# Access Compliance Report

## Public Rights-of-Way

### (Curb Ramps)

Intersection ID: 20640	Main Street: S_TRYON_ST	Cross Street: YAGER_CREEK_DR	Location: E
ADA ID: 37F1B09C93E7	Ramp Type: Perp	Initial Pass/Fail: Fail	Overall Compliance: No
Codes/Mitigation Info/Possible Solution		Field Measurements/Component Compliance	
Severity Score: 21.25

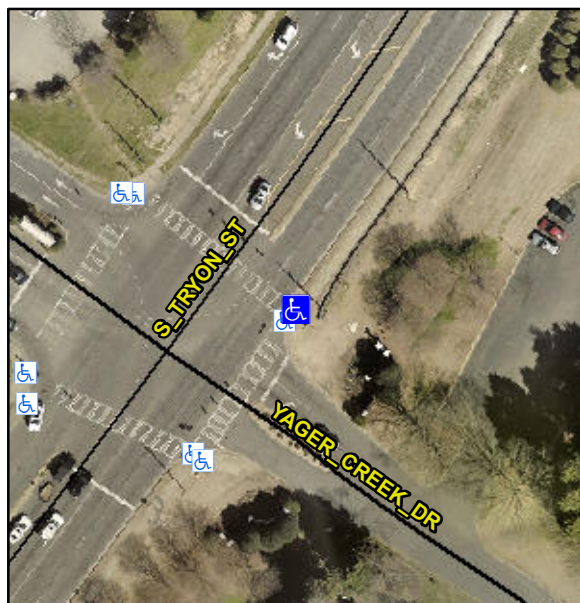
**Not Found, R304.5.1, R304.2.2**

Compliance	Description	Data	Compliance	Description	Data
N/A	Ramp Length (in)	77.0	No	Ramp Slope (%)	8.6
No	Ramp Width (in)	45.0	Yes	Ramp XSlope (%)	1.1
N/A	Flare Type LT	N/A	N/A	Flare Type RT	N/A
N/A	Flare Slope LT (%)	N/A	N/A	Flare Slope RT (%)	N/A
N/A	Flare Traversable LT?	N/A	N/A	Flare Traversable RT?	N/A
N/A	Landing Length (in)	N/A	N/A	DWS Provided?	N/A
N/A	Landing Width (in)	N/A	N/A	DWS Contrast?	N/A
N/A	Landing Slope (%)	N/A	N/A	DWS Length (in)	N/A
N/A	Landing X Slope (%)	N/A	N/A	DWS Full Width?	N/A
N/A	Landing Curb? (Y/N)	N/A	N/A	DWS Offset (in)	N/A
N/A	Shared Landing?	N/A			
N/A	Gutter Ponding?	N/A	N/A	Gutter Slope (%)	N/A
N/A	Gutter Lip Ht (in)	N/A	N/A	Gutter X Slope (%)	N/A
N/A	Painted X Walk1?	Yes	N/A	Painted X Walk2?	N/A
	X Walk 1 Direction	To NW		X Walk 2 Direction	N/A
N/A	X Walk 1 Width (in)	97.0	N/A	X Walk 2 Width (in)	N/A
	X Walk 1 Slope (%)	0.7		X Walk 2 Slope (%)	N/A
	X Walk 1 X Slope (%)	0.9		X Walk 2 X Slope (%)	N/A

N/A	Ramp inside XWalk1?	No	N/A	Ramp inside XWalk2?	N/A
	Road Slope (%)	N/A	N/A	Clear Space?	N/A
	Road X Slope (%)	N/A	N/A	Clear Space to XWalk (in)	N/A
N/A	Any Obstructions?	N/A	N/A	Storm Grate/Utility Hazard?	N/A
	Obstruction Type			Storm Grate/Utility Type	
		N/A			N/A
		Yes		Surface Condition? (G/P)	Good

**Remove & Replace Entire Ramp.  
Restripe Crosswalk.**
